AGENDA
REGULAR MEETING OF THE BIRMINGHAM PLANNING BOARD
WEDNESDAY SEPTEMBER 10, 2025 – 7:30 PM
151 MARTIN ST., CITY COMMISSION ROOM 205, BIRMINGHAM MI*

SUBJECT: 36977 Woodward Ave, InvestWise Financial – Preliminary Site Plan Review

The applicant has submitted an application for Preliminary Site Plan (PSP) review for the construction of a 3 (three) story office building in the TZ-3 (Transitional) Zoning District. The subject site is a vacant lot located at 36977 Woodward Ave (applicant refers to the lot as 36999 Woodward), on the corner of Quarton Road and Woodward Ave. The proposed development consists of one parcel. The subject property is adjacent to the recently completed development for 36877 Woodward Ave, Gasow Veterinary Hospital.

SITE PLAN

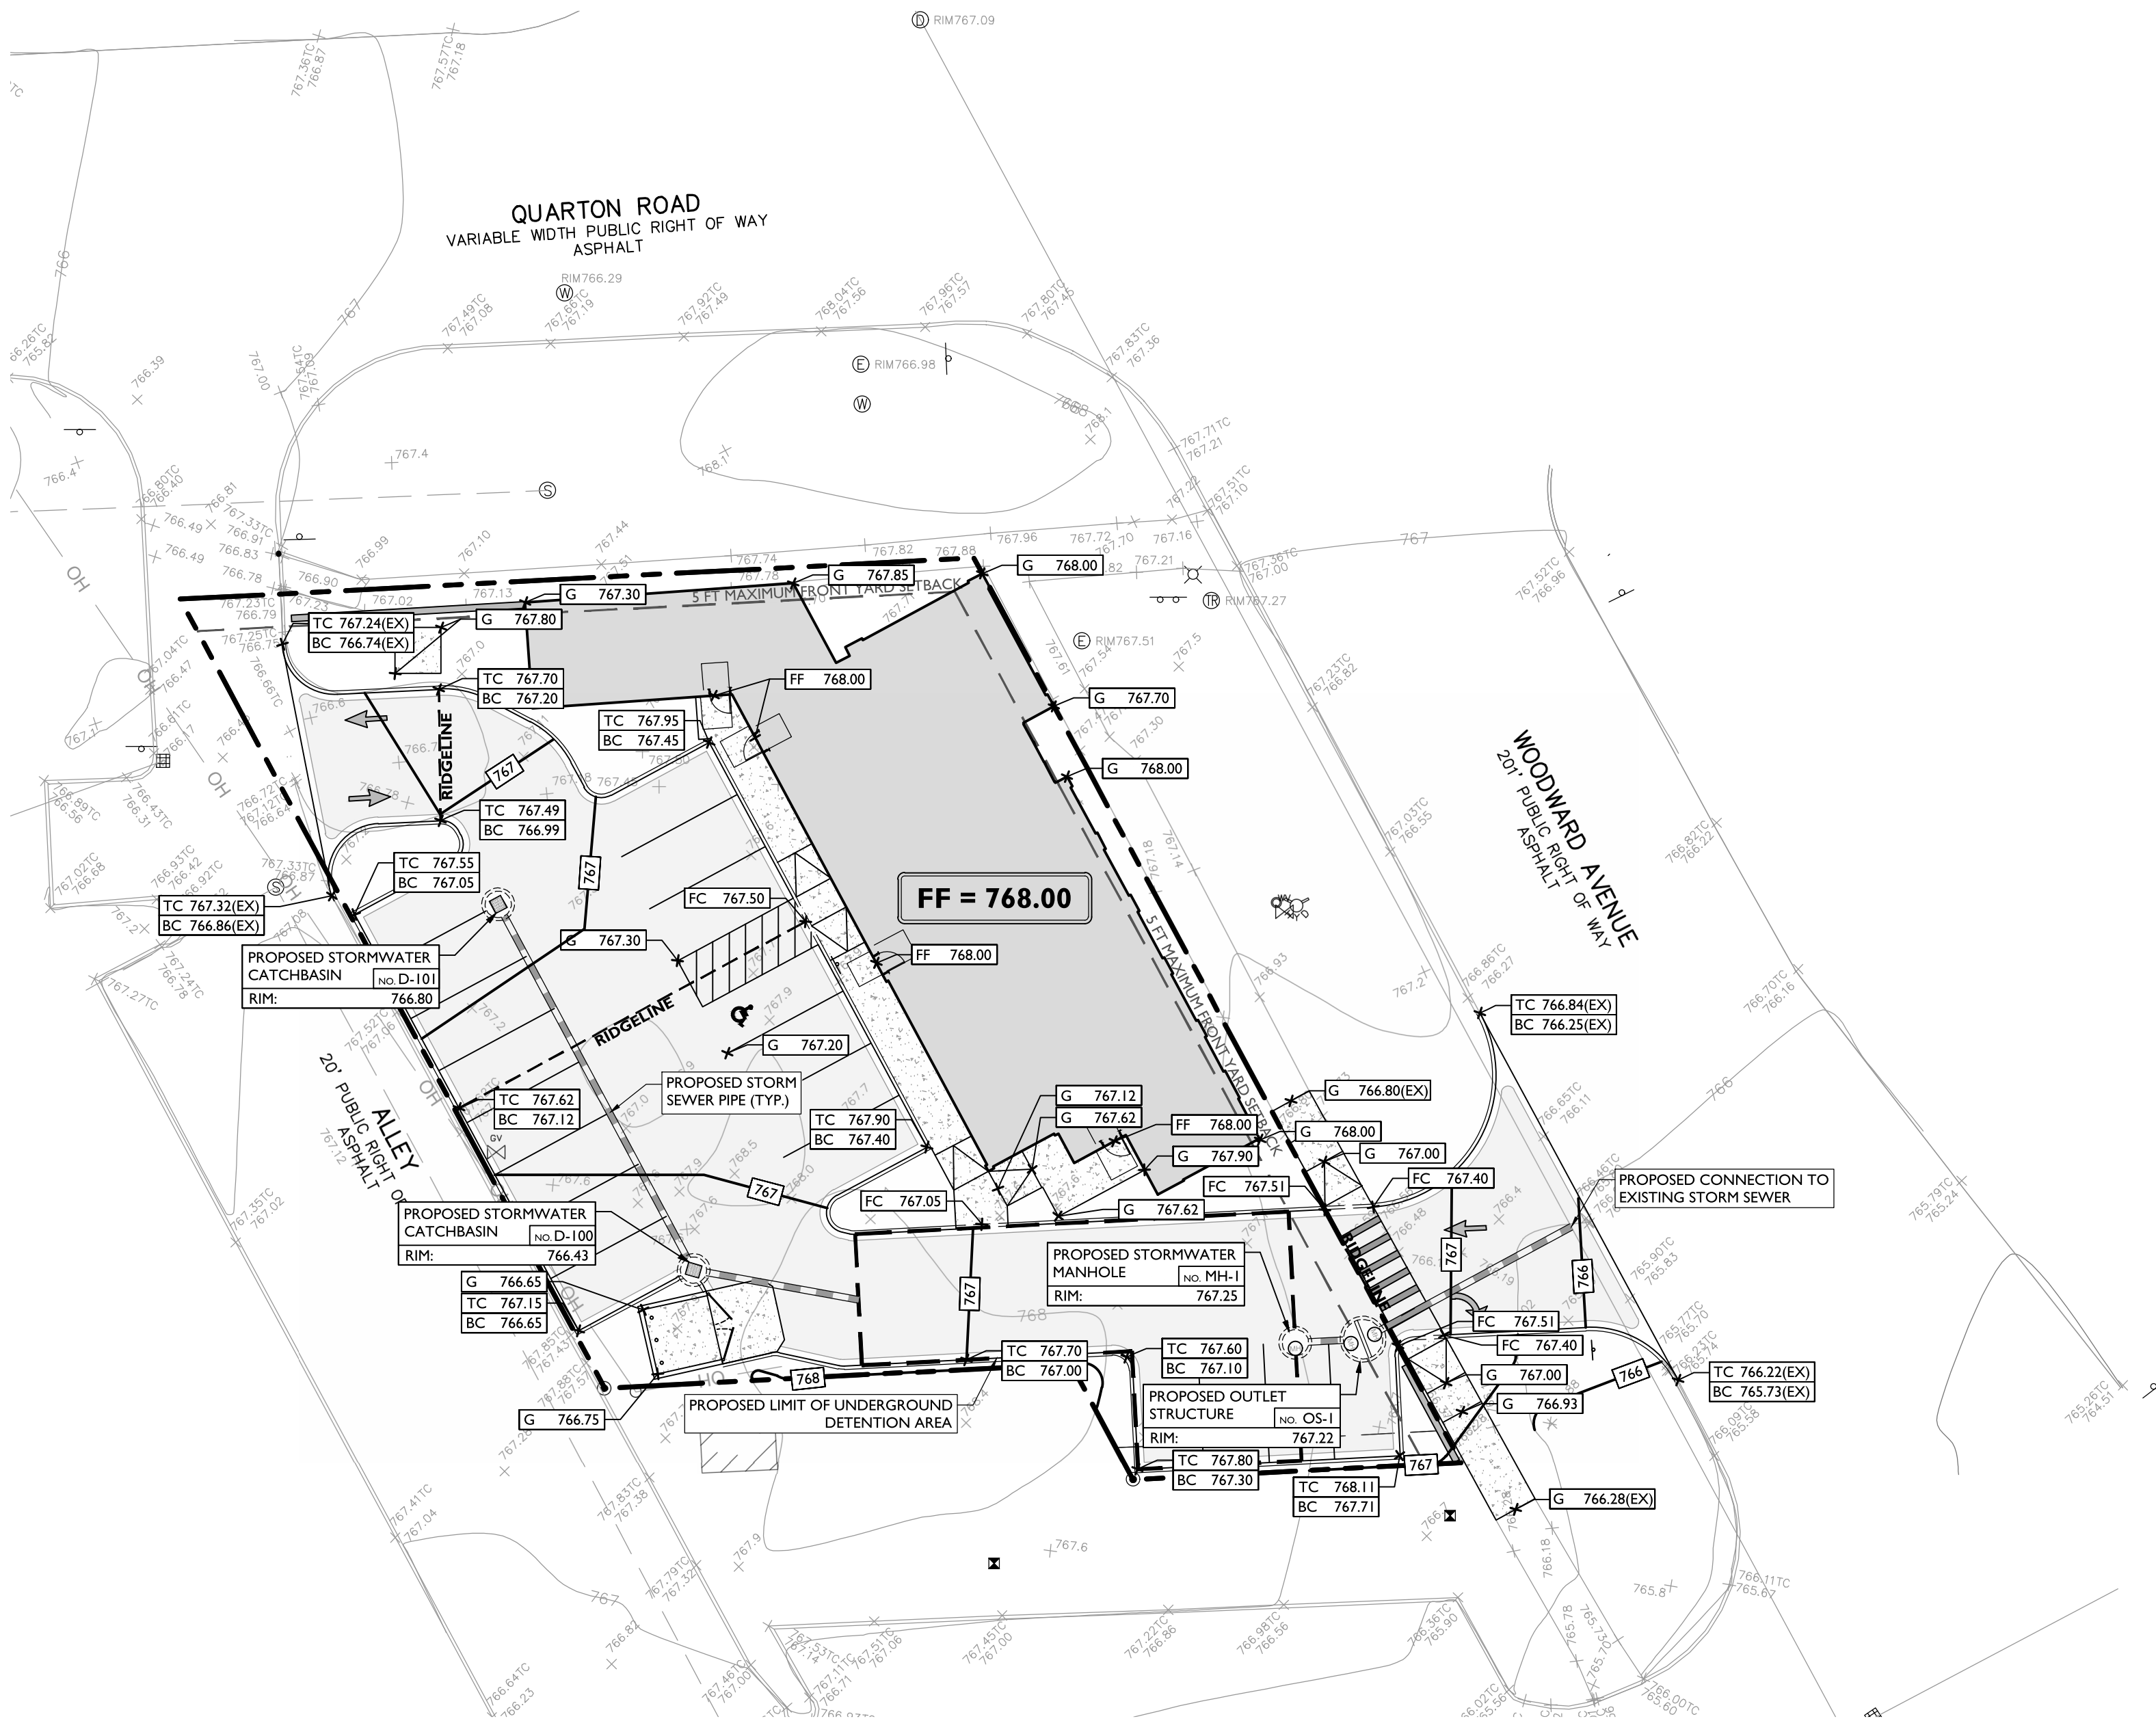
Article 2, Section 2.46.2 of the Zoning Ordinance requires the minimum front yard setback for the building façade to be built within 0-5 feet of the front setback requirement for a minimum of 75% of the street frontage length. The site plan indicates a building façade of 95.7 feet within 0-5 feet of the front lot line that is 156.5 feet in length, totaling 61.2% of frontage. **The applicant must modify the site plan to have 75% of the street frontage consist of building façade within 0-5 feet of the front lot line, or obtain a variance of 39.125 feet from the Board of Zoning Appeals**

The rear setback of the building is not clearly indicated on the plans. Staff approximated that the rear setback is approximately 40 ft, but **the applicant must make the rear setback clear on the site plan for Final Site Plan Review.**

parking lot. **Applicant will need to modify the site plan to have main entrance located on at least one (1) street front or obtain a variance from the Zoning Board of Appeals.**

3.1 Dumpster Screening – The applicant is proposing one dumpster on the southwest corner of the site facing the parking lot. The site plan indicates a trash enclosure with a screen wall and gates. Article 4, Section 4.54 B.9 of the Zoning Ordinance requires a screenwall that shall be constructed of capped masonry with access gates constructed of high quality and durable materials rated for exterior use such as wood, wood composite, metal or other materials acceptable to the Planning Board. **The applicant must indicate materials and dimensions of trash enclosure screenwall and gate for Final Site Plan review.**

3.2 Parking Lot Screening – The applicant is proposing on-site parking for a total of 19 spaces. The applicant has proposed three (3) foot tall screenwalls for parking along Woodward Ave and Quarton Road. The proposed building, along with proposed screenwalls appear to sufficiently screen parking from view. **Applicant must indicate length of proposed 3 foot screening wall off Quarton Road for Final Site Plan Review.**

The applicant is proposing a total of 19 parking spaces, including 1 ADA space. The ADA space appears to be 160 square feet, which is under the minimum space size per our ordinance at 180 square feet. **The applicant must revise the ADA space to the appropriate minimum size of 180 square feet.**

LIGHTING PLAN

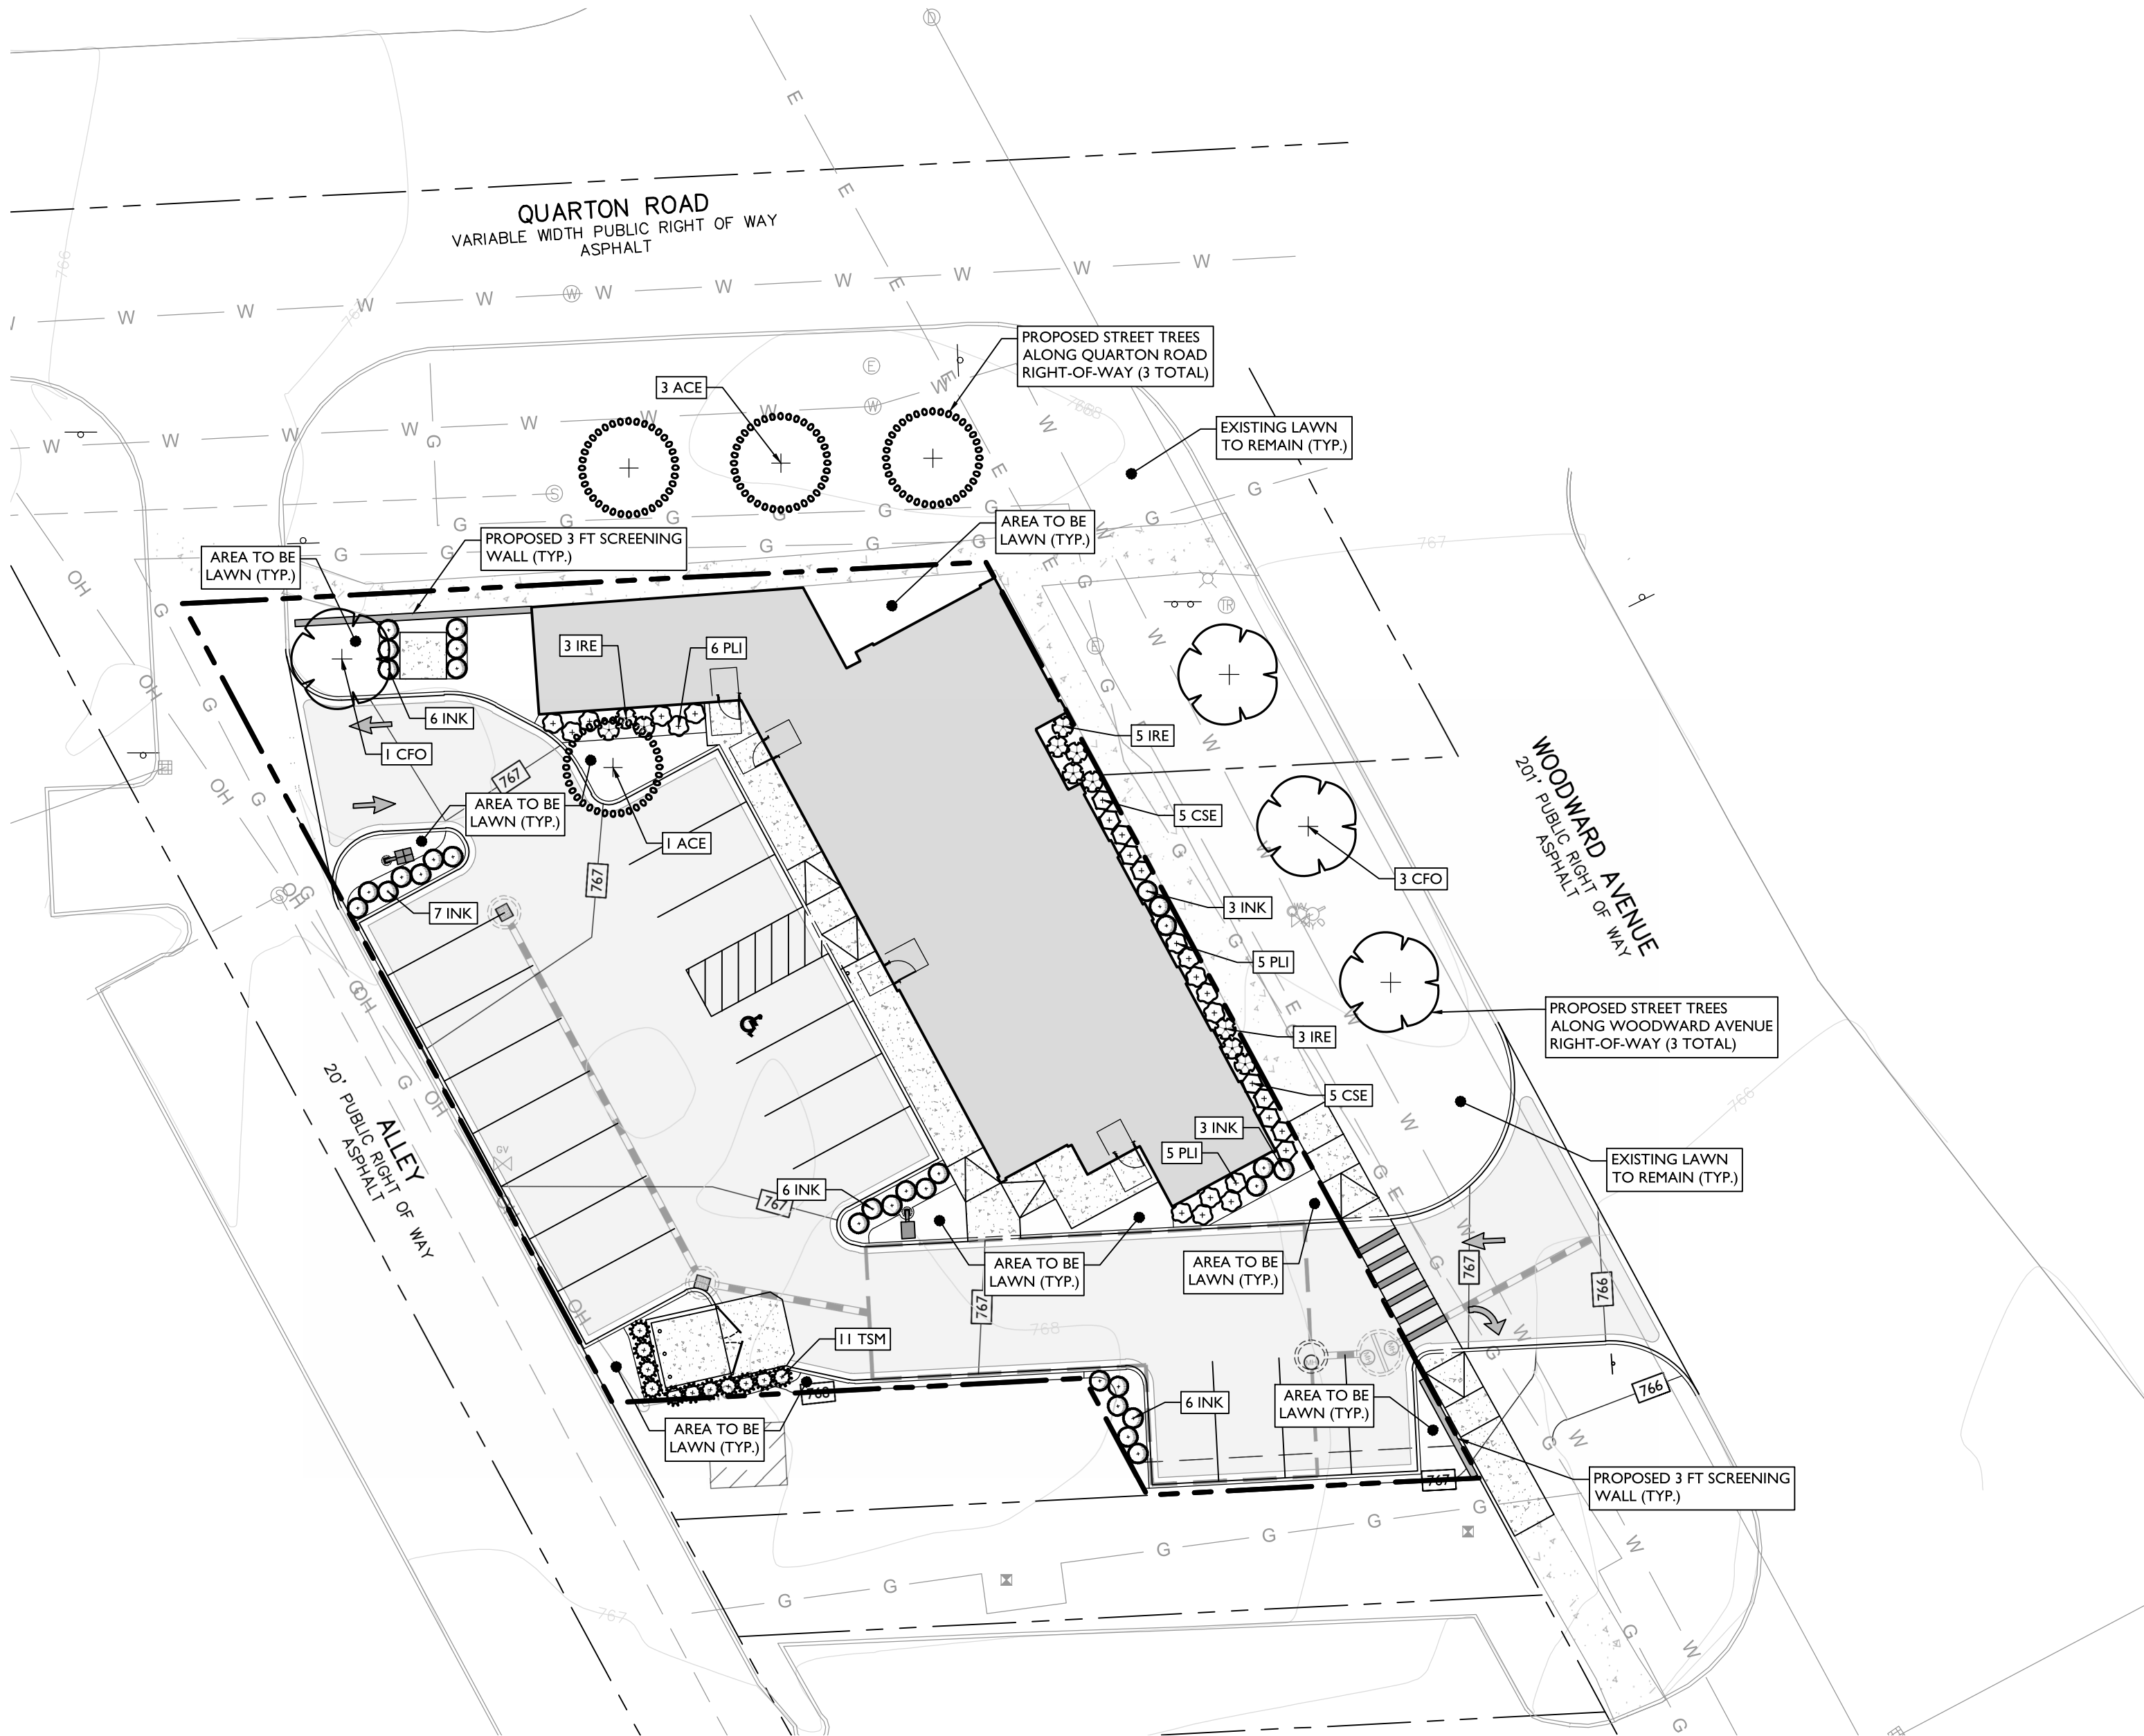
The site plan includes a photometric plan that indicates the addition of four types of lighting fixtures on the property. Two 16 ft pole fixture lights are proposed on site, while wall mounted light, totalling 13 wall mounted lights. **The Planning Division will provide a full review of the lighting proposal at Final Site Plan review.**

LANDSCAPING PLAN

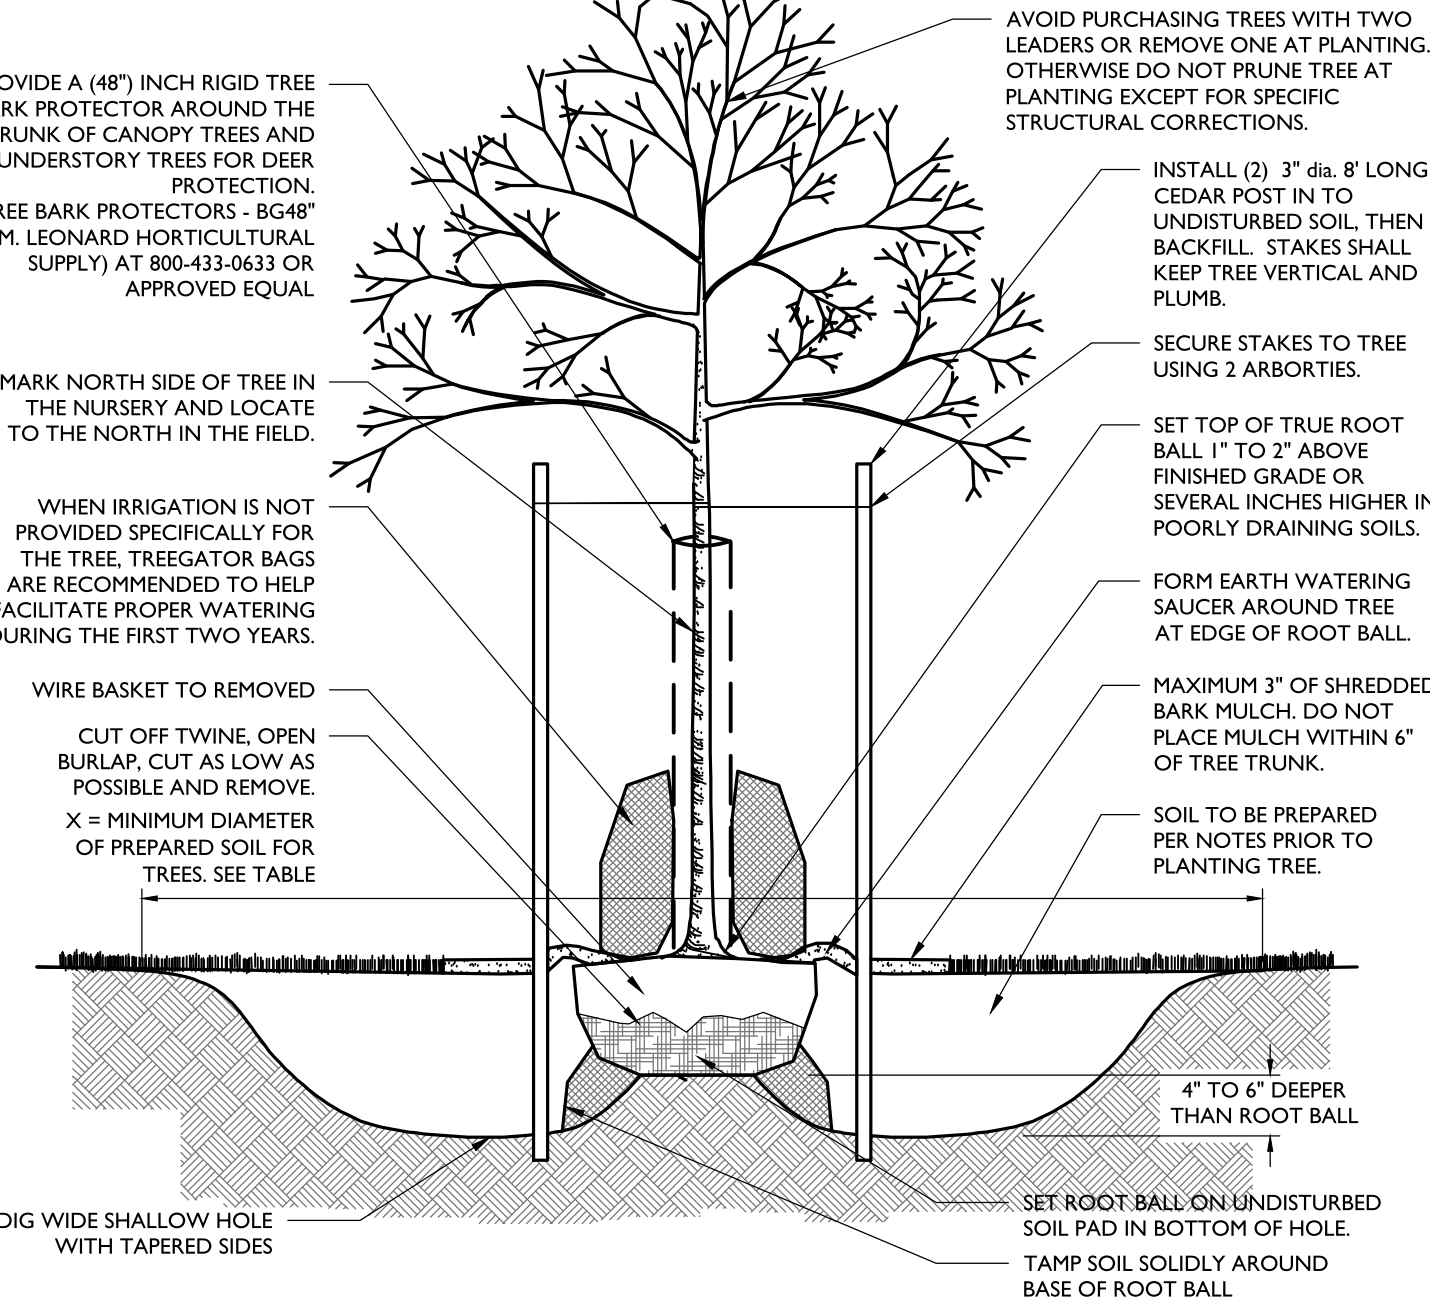
- Plan indicates installation of 3x Serviceberry in Quarton Rd easement, however, they are unlikely to succeed in proposed location and may cause line-of-sight issues for turning traffic. DPS recommends 3x more upright species tolerant of urban conditions such as Ginkgo biloba 'Princeton Sentry.'

- Plan indicates installation of 3x Cercis canadensis 'Forest Pansy' on Woodward easement, however, they are unlikely to succeed in proposed location and may cause line-of-sight issues for turning traffic, as well as potentially obstruct signs and pedestrian signals on site. DPS recommends 3x more upright species tolerant of urban conditions such as Ginkgo biloba 'Princeton Sentry' or Zelkova serrata 'Green Vase.'
